Project	IEEE 802.16 Broadband Wireless Access Working Group < http://ieee802.org/16 >
Title	ARQ selective bitmap clarifications
Date Submitted	2004-11-02
Source(s)	David Ashkenazi, david.ashkenazi@intel.com Voice: +972-54-5551083 Assaf Mor, Assaf.Mor@intel.com +972-54-5551067 Yigal Eliaspur, yigal.eliaspur@intel.com Voice: +972-547-884877 Yuval Lomnitz Yuval.Lomnitz@intel.com Intel Corp.
Re:	IEEE P802.16d/D5-2004
Abstract	ARQ selective bitmap clarifications
Purpose	
Notice	This document has been prepared to assist IEEE 802.16. It is offered as a basis for discussion and is not binding on the contributing individual(s) or organization(s). The material in this document is subject to change in form and content after further study. The contributor(s) reserve(s) the right to add, amend or withdraw material contained herein.
Release	The contributor grants a free, irrevocable license to the IEEE to incorporate material contained in this contribution, and any modifications thereof, in the creation of an IEEE Standards publication; to copyright in the IEEE's name any IEEE Standards publication even though it may include portions of this contribution; and at the IEEE's sole discretion to per

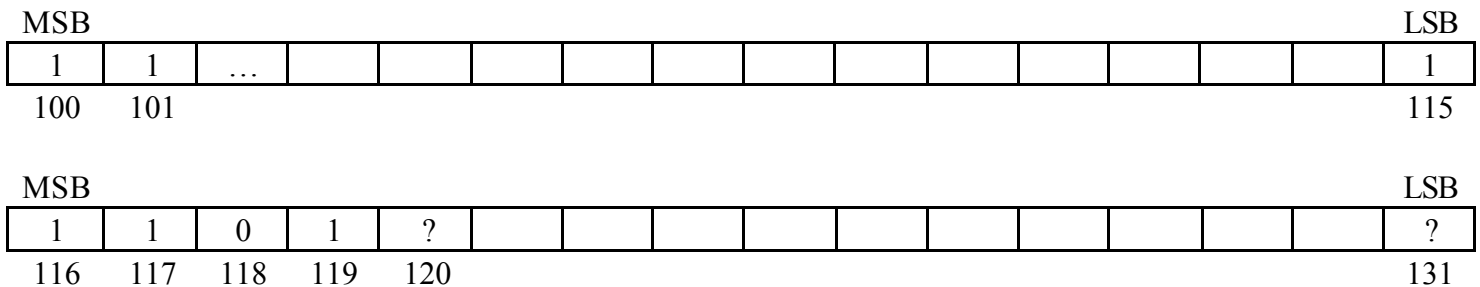
The two following example shows the ambiguity in the current scheme:

Receiver would like to report success for blocks 100 to 117, failure for block 118 and success for block 119.

The receiver will fill the following values to the MAP Feedback IE:

- BSN=100
- Number of Ack Maps = 2
- Ack type = 0

The two MAPS will look as follows:

There is an ambiguity on BSN 119 to 131. If zero will be used as a report does it indicate NACK or should it be ignored?

In the selective ACK case (ACK type 0x0 and 0x2) BSN should be assign appropriately so that the last block to be reported is reported via the LSB of the last ACK Map .

The BSN field should be adjusted accordingly - BSN of last reported block number minus the total MAPs size.
